**RE: Balloon Fiesta Park – Site Infrastructure Improvements  
9201 Balloon Museum Dr NE  
Grading and Drainage Plan  
Engineer’s Stamp Date: 03/03/2026  
Hydrology File: B17D001  
Case # HYDR-2026-00081**

Based upon the information provided in your submittal received 03/04/2026, the Grading & Drainage Plan is not approved for Rough Grading. The following comments need to be addressed for approval of the above referenced property:

SHEET C-102

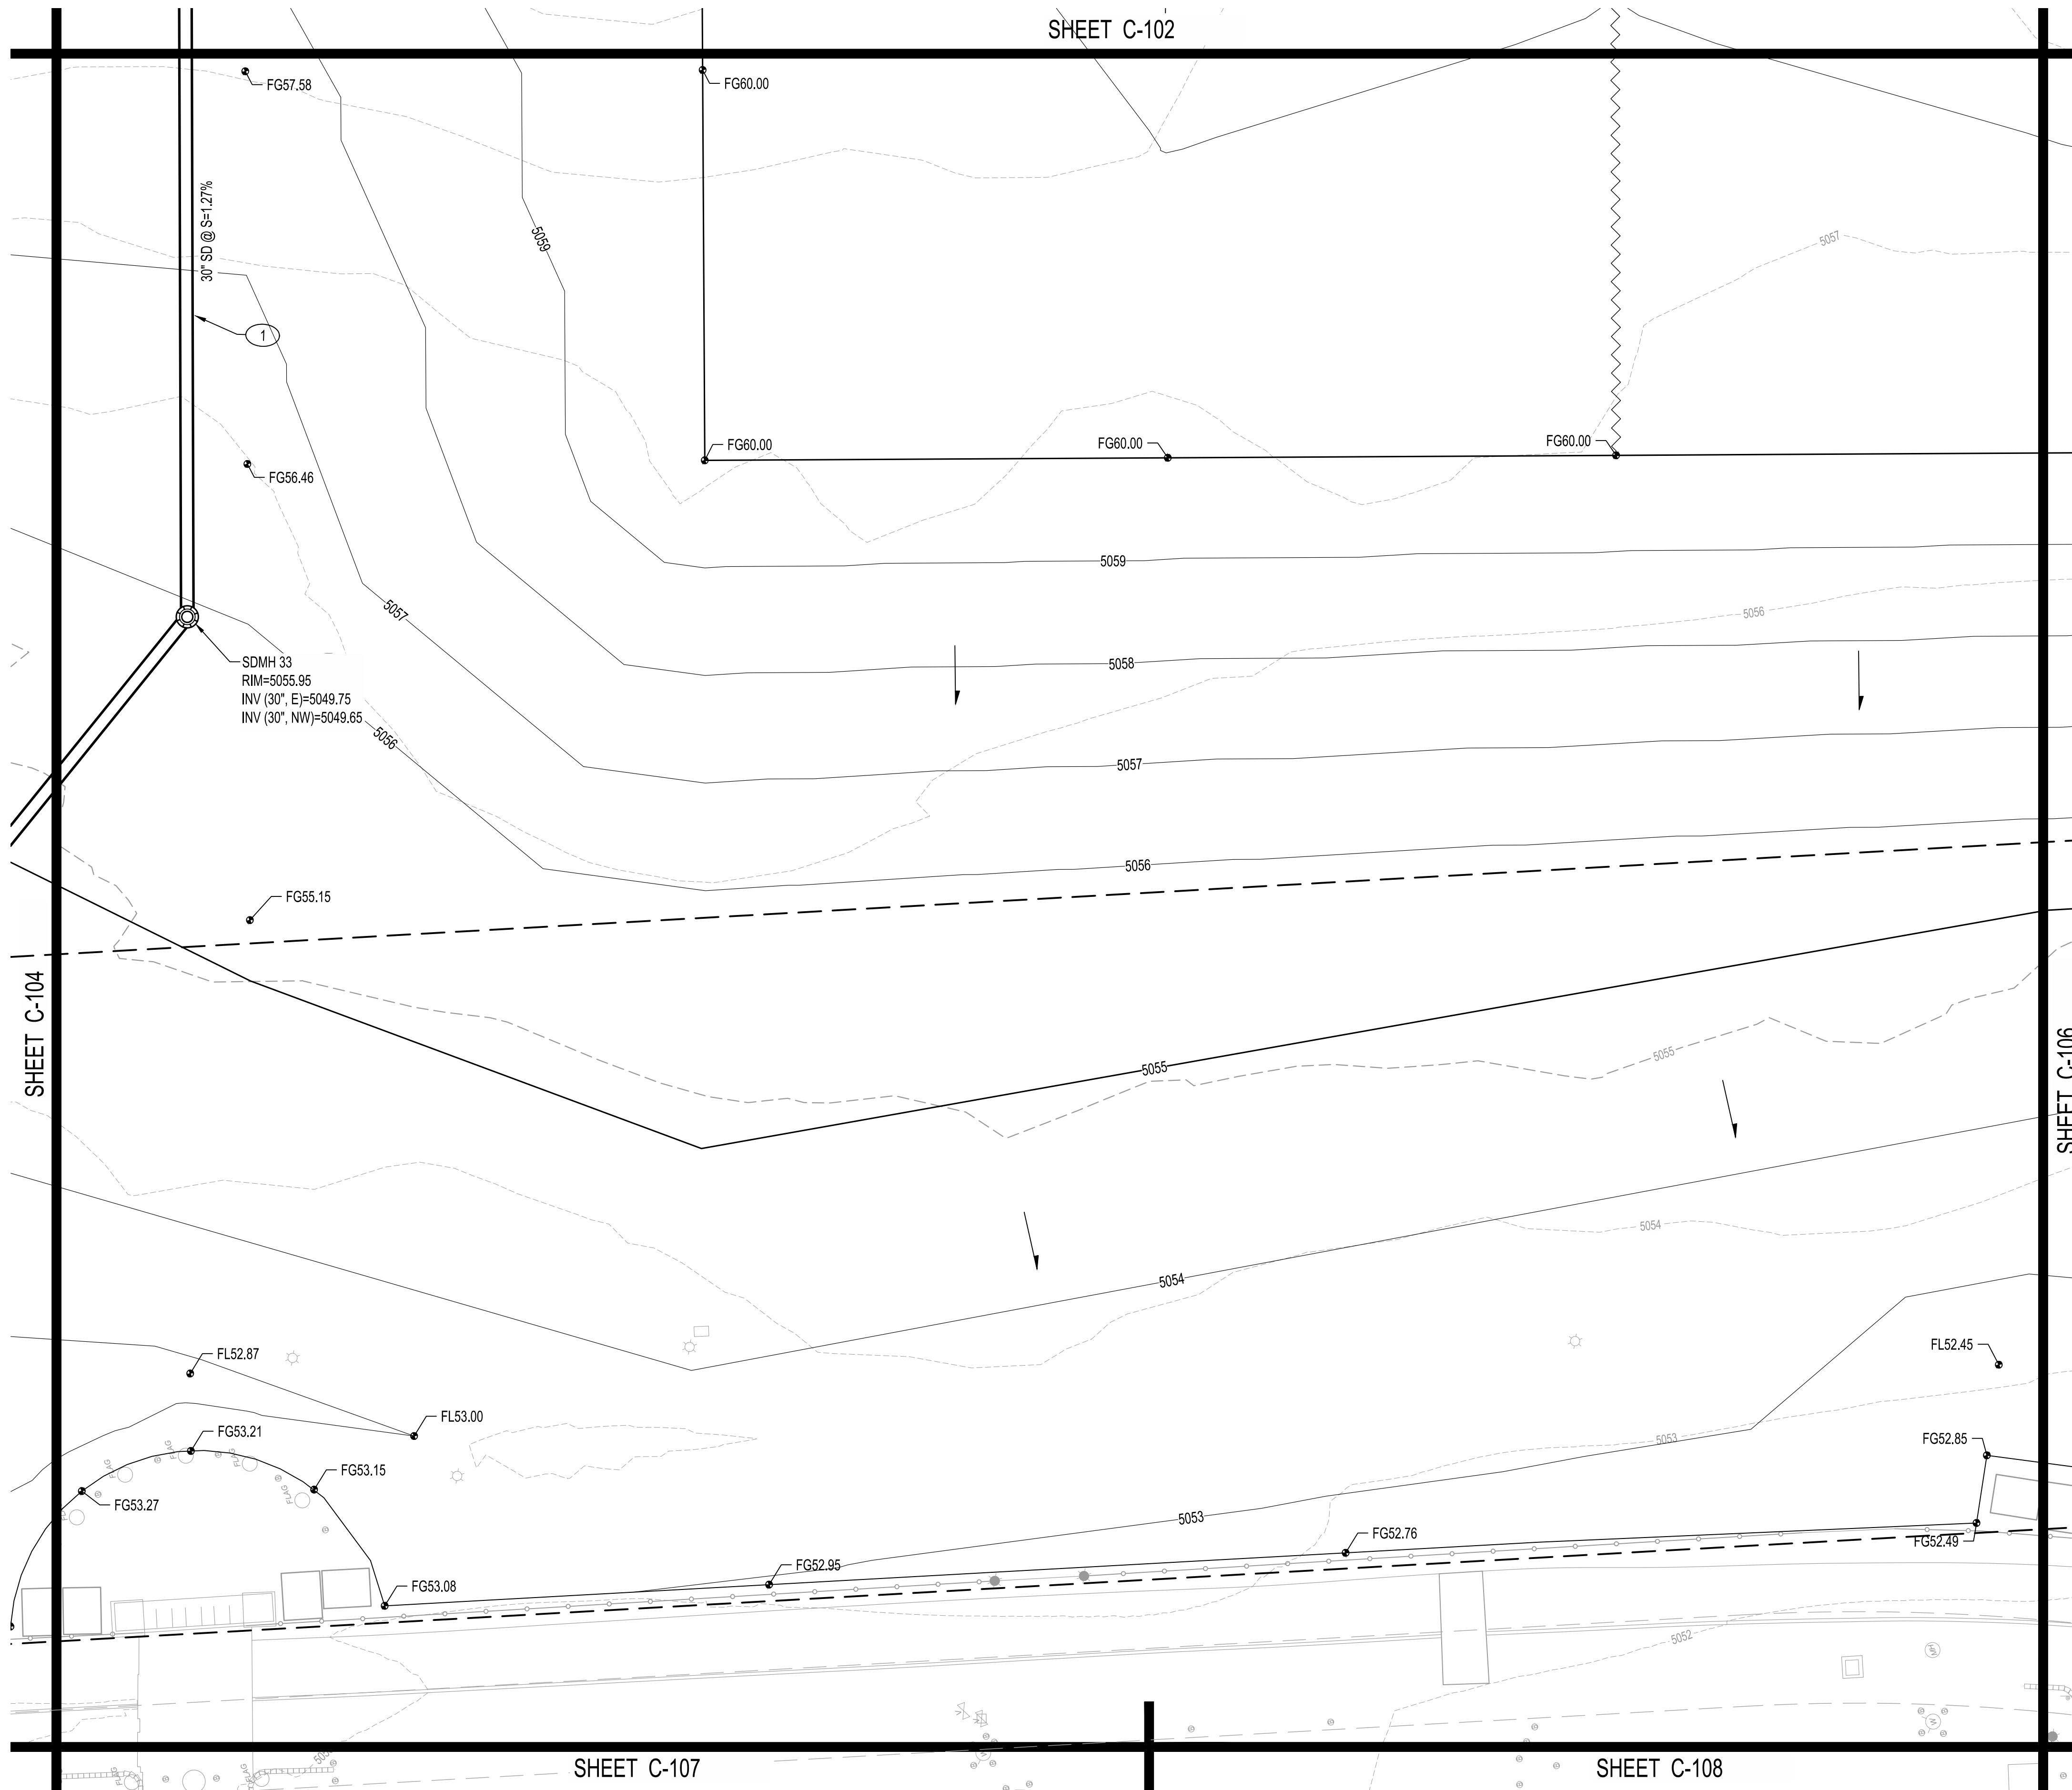
5. P. 9-16 – Sheets C-101 through C-108 – Only call out RCP on grading keyed notes, remove HDPE.
